MECKLENBURG COUNTY
GROUNDWATER & WASTEWATER SERVICES

Re: Request for a Revision to the Septic Improvement Permit and a Septic Construction Authorization for Lot 108 at The Sanctuary at Lake Wylie

Mecklenburg County Health Department (MCHD) File #6347B

Design Specifications for Lot 108 at The Sanctuary
MCHD File # 6347B

LOT 108
THE SANCTUARY
MECKLENBURG COUNTY, NORTH CAROLINA

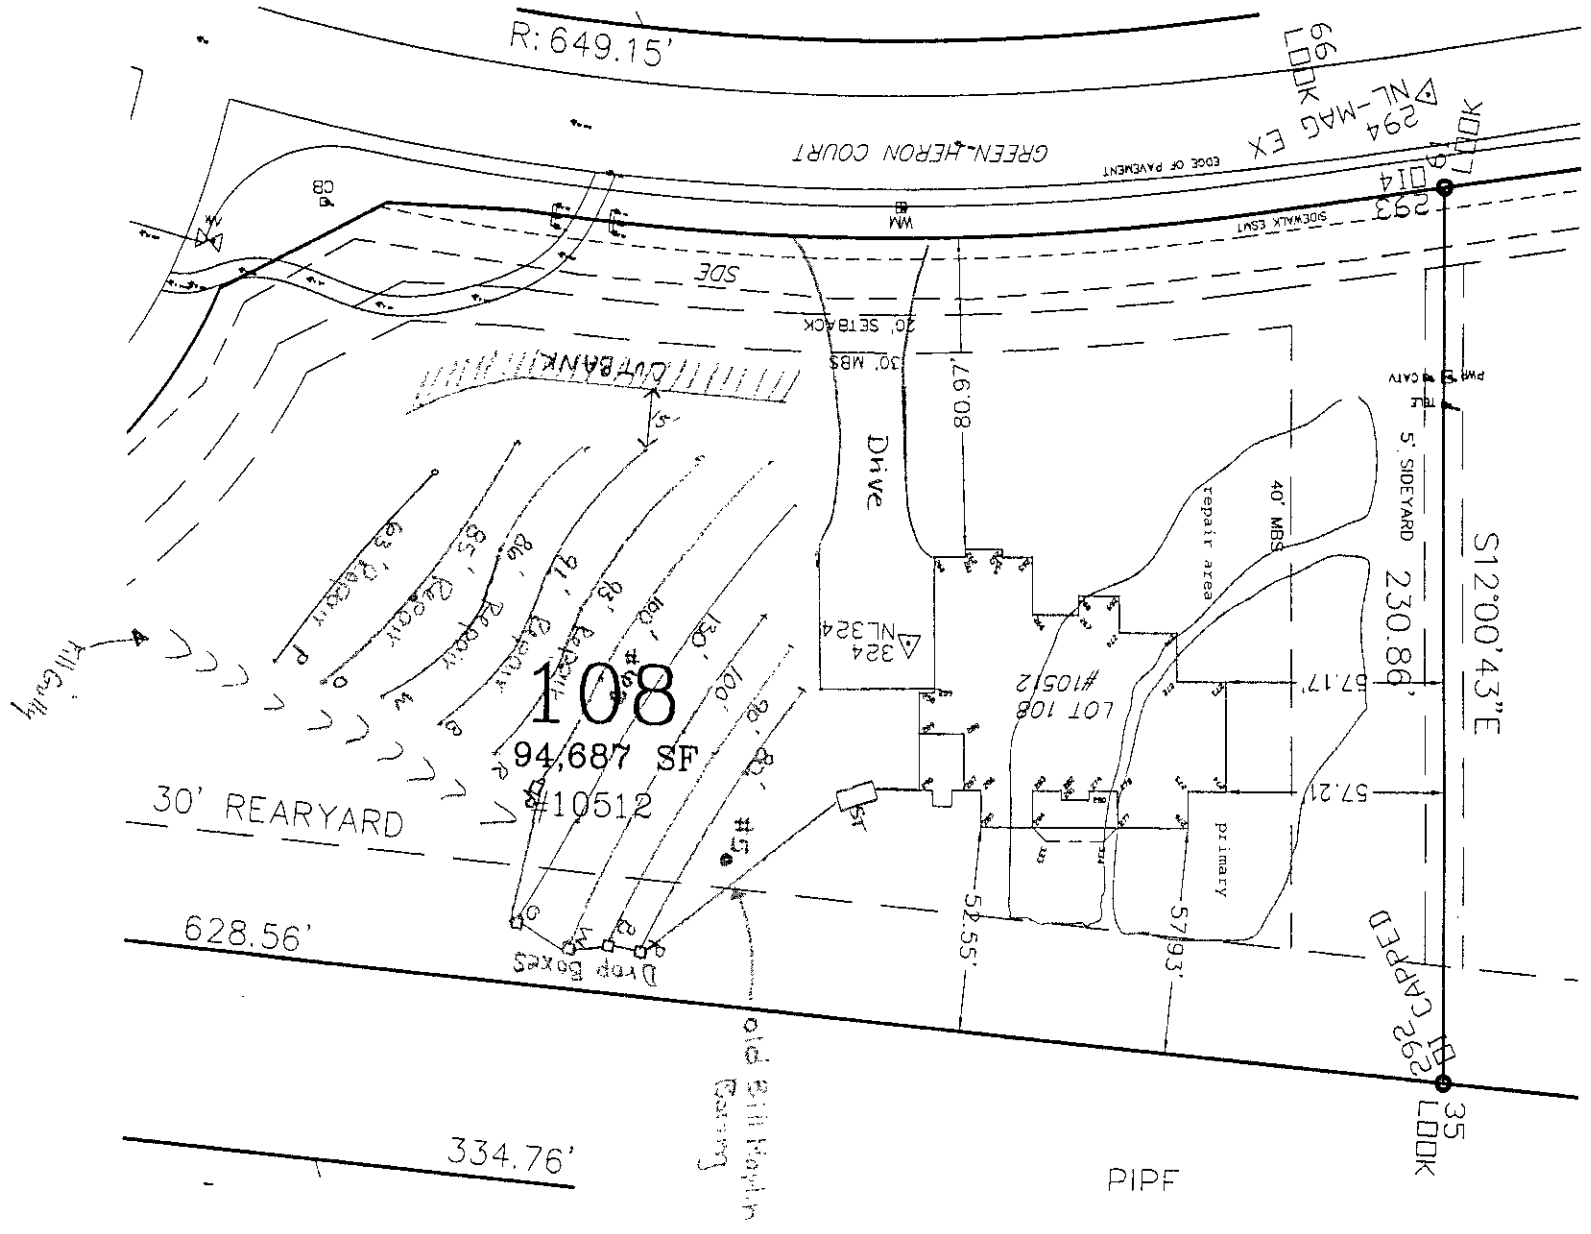
Regal Custom Home Builders, LLC is requesting the original Improvement Permit for the above referenced lot be revised for a new house and driveway plan, and a Construction Authorization be issued for a five bedroom house (see attached Site Plan). Mr. Bill Marlin, LSS with the MCHD had evaluated the soils and approved the proposed septic area at a 0.3 gpd/sqft LTAR in the original system area (see attached S&ME packet and MCHD soil notes). S&ME, Inc. (S&ME) has since evaluated the soils and flagged the primary system and repair area in the new proposed septic area on the lot. The attached sketch and specifications are not an Improvement Permit or Construction Authorization and are intended only to assist the MCHD in permitting the referenced lot at The Sanctuary.

S&ME is proposing a gravity fed 25% Reduction initial system and an LP PPBPS repair at a 0.3 gpd/sqft. LTAR. Neither the soils nor the system design has been reviewed on site by the MCHD at this time. We understand that a building permit cannot be issued until your office issues an Authorization to Construct (ATC). **No grading shall take place on the lot prior to obtaining the ATC from the MCHD.**

Please review the attached system sketch and design specifications for the Improvement Permit and Construction Authorization. Any additions or revisions you feel are necessary can be made on the Improvement Permit. Please call if you have any questions or comments.

Daily Design Flow:	600 gpd
Number Bedrooms:	5 bedroom
Basement or Crawl Space:	Crawl Space
Septic Tank Size:	1500 gal
Primary System Loading Rate:	**0.3 gpd/ft^2**
Primary System:	**25% Reduction**
Number and length of laterals:	1 @ 80 ft. 1 @ 90 ft. 2 @ 100 ft. 1 @ 130 ft.
Total ft. of primary system:	500 ft.
Distribution Device:	Drop Boxes
Repair System Loading Rate:	**0.3 gpd/ft^2**
Repair System:	**LP PPBPS**

LOT 108
THE SANCTUARY
MECKLENBURG COUNTY, NORTH CAROLINA

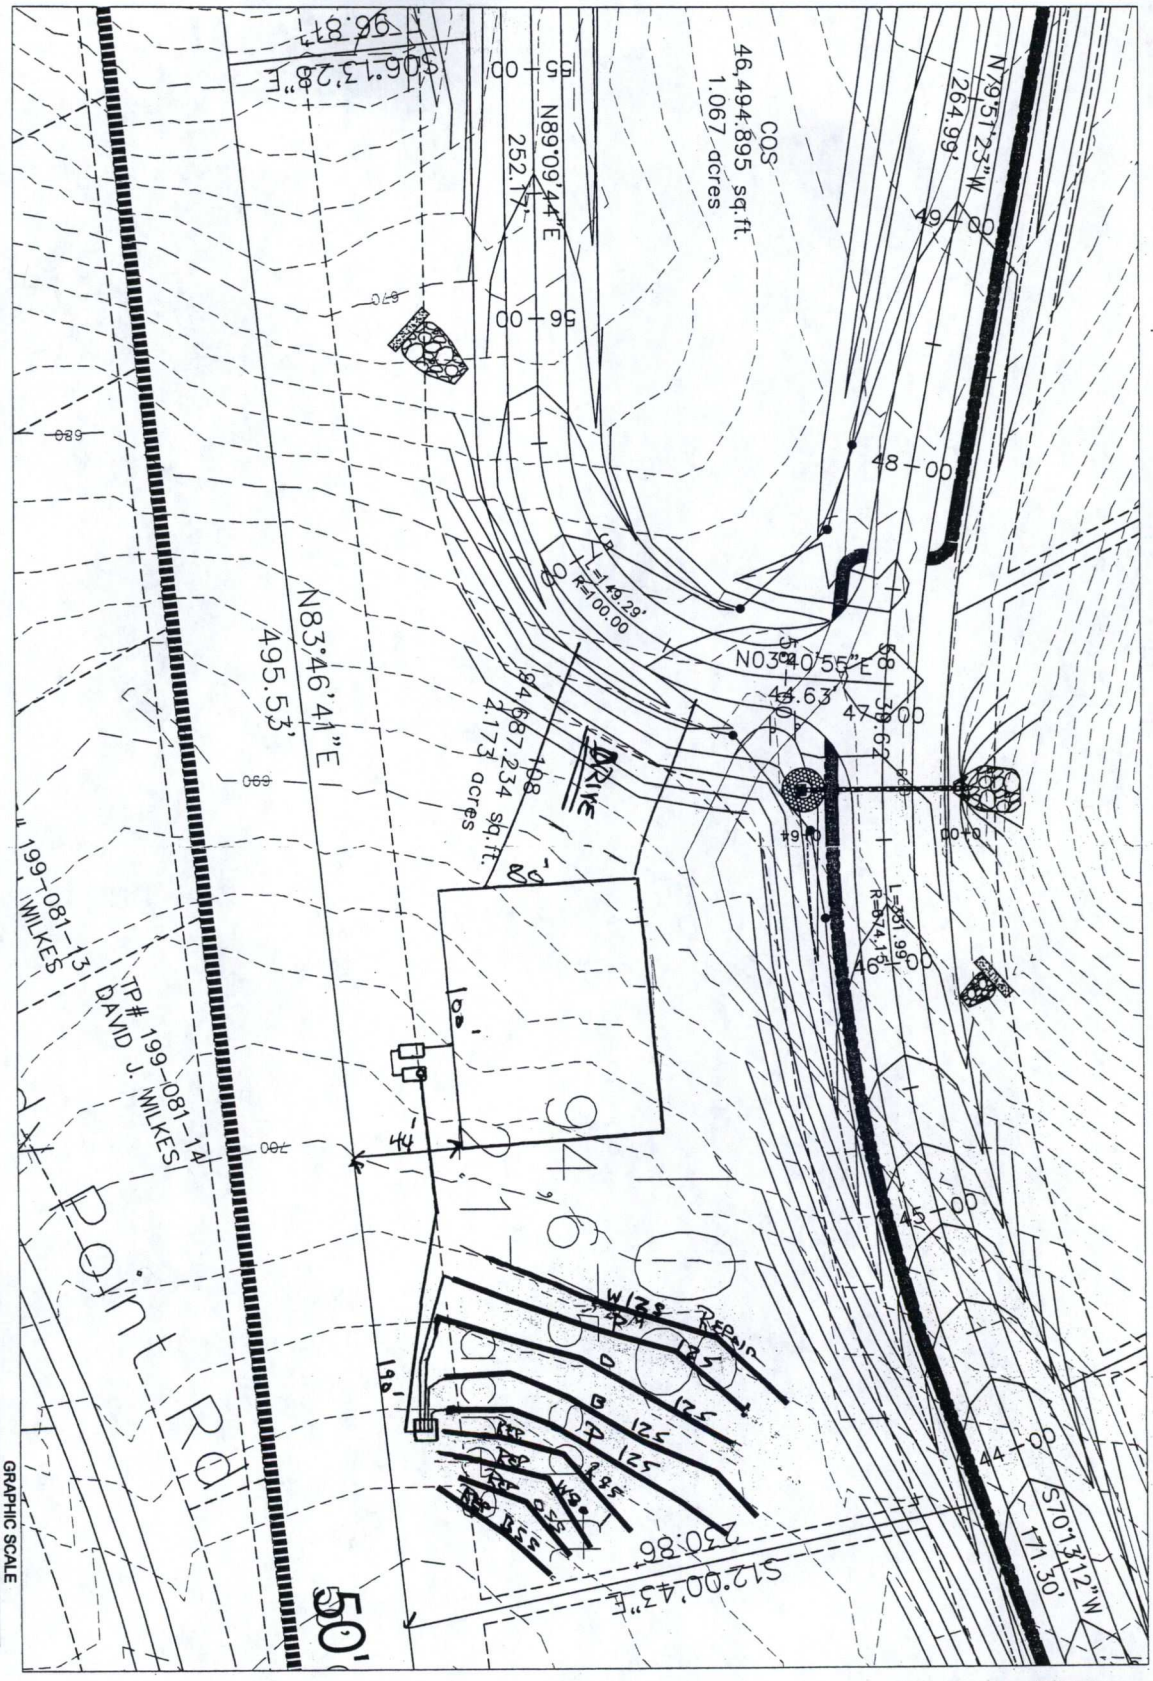
The Sanctuary at Lake Wylie is requesting an Improvement Permit for the above referenced lot. Mr. Bill Marlin has evaluated the soils (see attached MCHD soil sheets) and S&ME, Inc. has flagged the system and repair on the lot. The septic lines have been located by the surveyor and are shown on the attached maps provided by LandDesign Engineering. The attached sketch and specifications are not an Improvement Permit and are intended only to assist the MCHD in permitting the referenced lot at The Sanctuary.

Please review the attached system sketch and design specifications for the Improvement Permit. Any additions or revisions you feel are necessary can be made on the Improvement Permit. Please call in you have and questions or comments.

Daily Design Flow:	600 gpd
Number Bedrooms:	5 bedroom
Basement or Crawl Space:	Crawl Space
Septic Tank Size:	1500 gal
Pump Tank Size:	1500 gal
Primary System Loading Rate:	**0.3 gpd/ft^2**
Primary System:	**25% reduction**
Number and length of laterals:	4 @ 125 ft. endfed
Total ft. of primary system:	500 ft.
Flow Rate through system:	22 gpm – use ½ in. SCH 80 taps with 2 ft. head pressure on pressure manifold (5.5 gpm per tap)
Pump Requirements:	to be calculated by installer when specific house and pump tank locations are available
Dosing Volume:	approx. 270 gal. – 2.2 doses/day at design flow
Depth of effluent pumped per dose:	calculated to specific tank by measure or dealer engineering specifications (1 cubic ft. of water equals 7.48 gal.)
Check Valve:	yes
Siphon break hole:	no
Repair System Loading Rate:	**0.3 gpd/ft^2**
Repair System:	**LP PPBPS**
Total ft. of repair	400 ft. (334 required)
